Access Compliance Report Public Rights-of-Way (Curb Ramps)

Main Street: N/A Cross Street: LA_COLINA_DR Location: W

ADA ID: RPRK220125115015 Ramp Type: Type 1 - Perpendicular Diagonal Initial Pass/Fail: Fail Overall Compliance: No Severity Score: 45

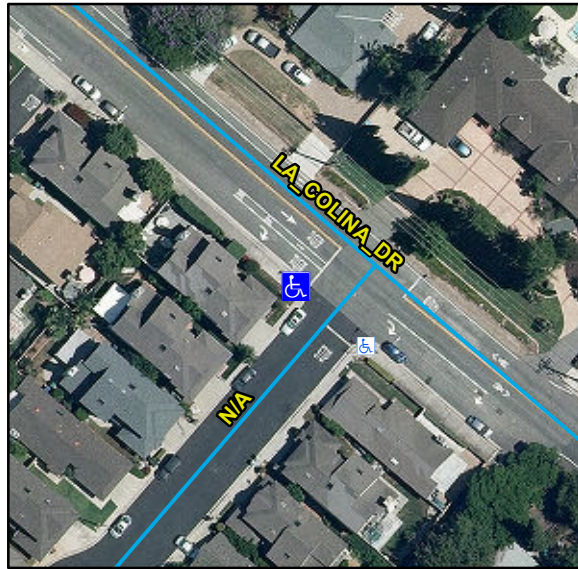
Compliance	Description	Data	Compliance	Description	Data
N/A	Ramp Length (in)	78	N/A	Flare Type LT	
Yes	Ramp Width (in)	48			N/A
No	Ramp Run Slope (%)	13.1	N/A	Flare Slope LT (%)	N/A
No	Ramp Cross Slope (%)	5.1	N/A	Flare Traversable LT	N/A
N/A	Landing Present	N/A	N/A	Flare Type RT	
N/A	Landing Length (in)	N/A			N/A
N/A	Landing Width (in)	N/A	N/A	Flare Slope RT (%)	N/A
N/A	Landing Run Slope (%)	N/A	N/A	Flare Traversable RT	N/A
N/A	Landing Cross Slope (%)	N/A	N/A	DWS Provided	N/A
N/A	Landing Movement Obstructed?	N/A	N/A	DWS Contrast	N/A
	Landing Movement Type	N/A	N/A	DWS Length (in)	N/A
N/A	Landing Shared	N/A	N/A	DWS Full Width	N/A
N/A	Clear Space	Yes	N/A	DWS Offset Left (in)	N/A
N/A	Clear Space To Crosswalk (in)	N/A	N/A	DWS Offset Right (in)	N/A
N/A	Marked Crosswalk 1	No	N/A	Marked Crosswalk 2	No
	Crossing 1 Direction	SE		Crossing 2 Direction	NE
	Marked Crosswalk 1 Width (in)	N/A		Marked Crosswalk 2 Width (in)	N/A

N/A	Ramp Inside Crosswalk 1	N/A	Yes	Ramp Inside Crosswalk 2	N/A
	Crossing 1 Slope (%)	4.4		Crossing 2 Slope (%)	2.9
	Crossing 1 Cross Slope (%)	4.8		Crossing 2 Cross Slope (%)	0.5
N/A	Gutter Ponding	N/A	N/A	Curb Slope	3.1
No	Gutter Lip Height (in)	0.25		Road Run Slope (%)	2.7
N/A	Gutter Run Slope (%)	N/A		Road Cross Slope (%)	2
N/A	Gutter Cross Slope (%)	N/A			
Yes	Overall Surface Condition: Acceptable		No	Perp Joint Present	No
	Cross Gutter Present?	No		Spandrel Present?	No
	Replace Cross Gutter?	N/A		Replace Spandrel?	N/A

Remove & Replace Curb Ramp With Two New Directional Ramps or Equivalent. Grind Gutter Lip.
